SUNDRY NOTICES AND REPORTS ON WELLS (DO NOT USE THIS FORM FOR PROPOSALS TO DRILL OR TO DEEPEN OR PLUG BACK TO A DIFFERENT RESERVOIR. USE "APPLICATION FOR PERMIT" (FORM C-101) FOR SUCH PROPOSALS.)		WELL API NO. 30-015-22294

2. Name of Operator EOG Resources, Inc.		6. State Oil & Gas Lease No.
3. Address of Operator 104 South Fourth Street, Artesia, NM 88210		7. Lease Name or Unit Agreement Name Ferguson IF

# Ferguson IF #2

## Proposed P&A

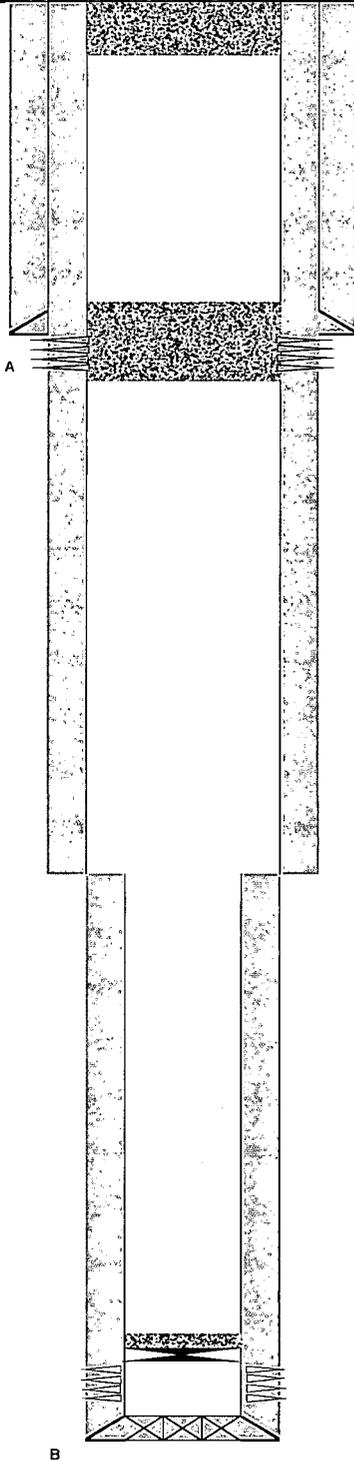
Perf @ 2432-2726

- MIRU all safety equipment as needed. POOH with production equipment.
- Set a CIBP at ~~2818'~~ with 35' Class "C" cement on top. - CIBP @ 2380' - WOC + Tag 7"
- Perforate at 1200'. Attempt to establish circulation. Spot a 25 sx Class "C" cement plug from 1200'-962'. WOC and tag. This will plug the 8-5/8" casing shoe.
- Spot a 10 sx Class "C" cement plug from 95' up to surface. WOC and tag plug. This will plug the top.
- Cut off wellhead and weld on dry hole marker. Clean location as per regulated.

*\* See Attached COA's must be plugged by 5/31/20*
